APPEAL SUMMARY

Appeal ID: 18966	Project Address: 1075 NW 16th Ave
Hearing Date: 2/6/19	Appellant Name: Tom Jaleski
Case No.: B-019	Appellant Phone: 971-238-5266
Appeal Type: Building	Plans Examiner/Inspector: Corey Stanley
Project Type: commercial	Stories: 6 Occupancy: A-3, B, R-2, & S-2 Construction Type: III-A OVER I-A
Building/Business Name: Derby Slabtown Apartments	Fire Sprinklers: Yes - Throughout
Appeal Involves: Reconsideration of appeal	LUR or Permit Application No.:
Plan Submitted Option: pdf [File 1]	Proposed use: Apartments

Engineering Judgement Letter

Derby Slabtown Apartments - EJ #1

Figure 1: Location of C6x13 steel members at level 01.

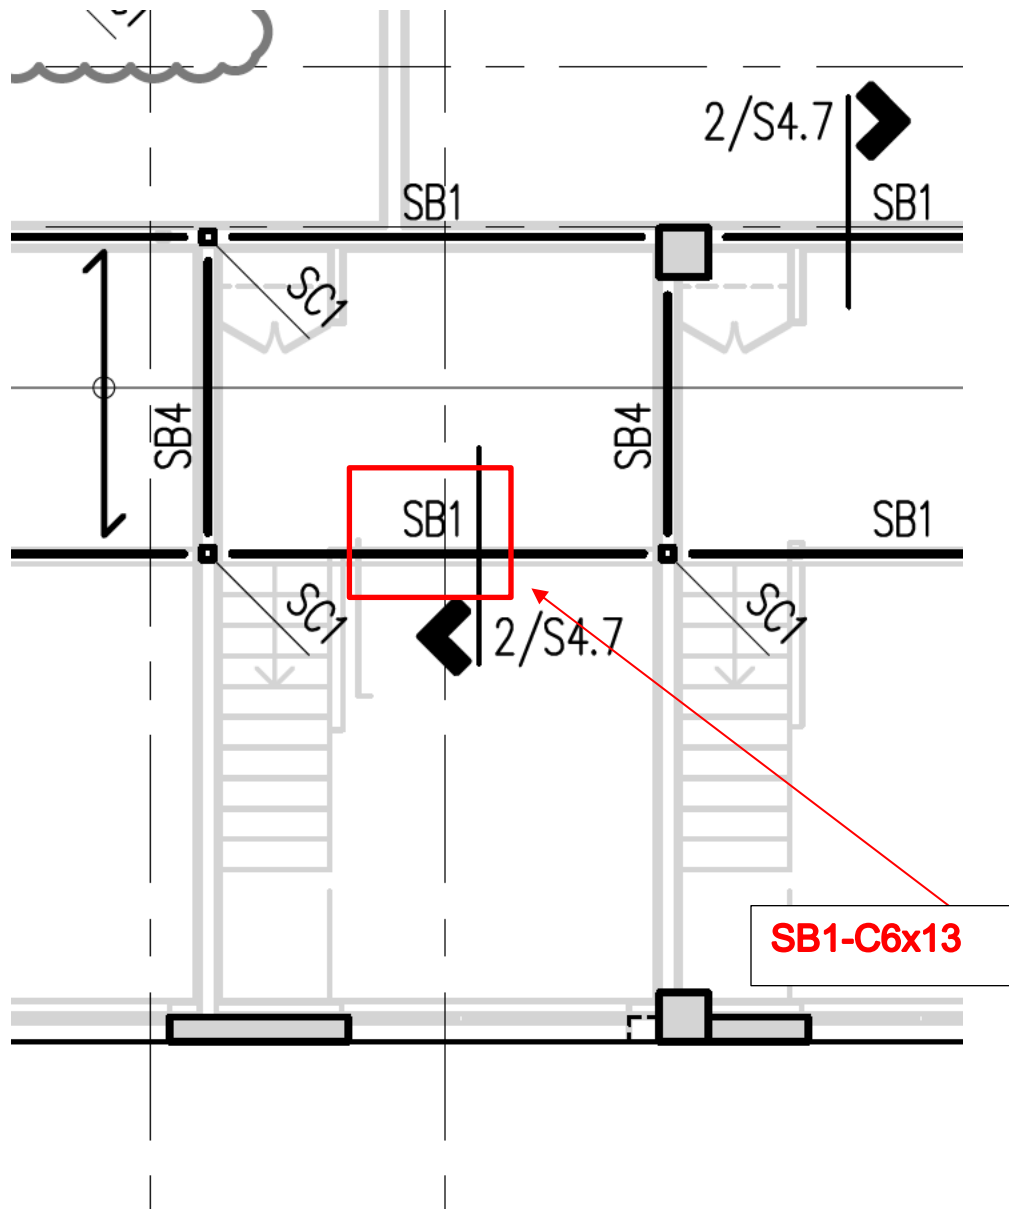
The proposed design assemblies are steel support members installed against a mezzanine concrete floor. Two similar conditions are analyzed (L-3x3x ¼ and C6x13(W/L2x2x¼), located at the level 01-Mezz of the building (see fig 1).

The C-member is exposed on all 3 sides with an L2x2x ¼ adjacent. The L3x3x ¼ -member, is exposed on the bottom side only. They will be protected equally with 2-hr fire resistance rated per 2014 OSSC §704.3.

Figure 2: C6x13 Member

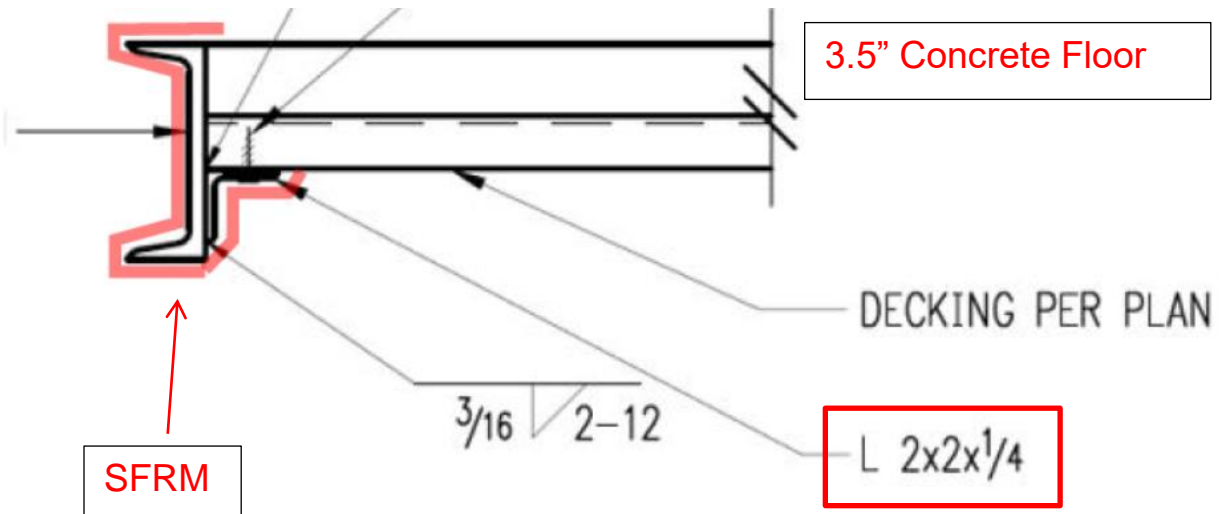
Proposed Design The proposed design assemblies are steel support members installed against mezzanine concrete floor. Two similar conditions are analyzed (L-3x3x ¼ and C6x13), located at the level 01-Mezz of the building.

The C-member is exposed on all 3 sides, while the L-member, only the bottom side. They will be protected equally with 2-hr fire resistance rated per 2014 OSSC §704.3.

The proposed assembly members protected by SFRM coating with a minimum thickness as identified in the EJ#1 (see attachment – EJ#1) will provide protection for a 2-hr rating based on the comparison to the UL test data and our analysis. The complete fire proofing as detailed in the EJ will provide a conservative level protection for the members. The proposed protection will meet the minimum 2-hr fire resistance rating per the OSSC for this application. Therefore, we urge you to approve this appeal.

"Reconsideration Text"
 Evaluated protection thickness has been compared to a thinner beam member and additional SFRM protection has been provided as a conservative measure. See revised EJ.

Alternate 2 hour fire rated steel support member assembly with engineering analysis: Granted as proposed.
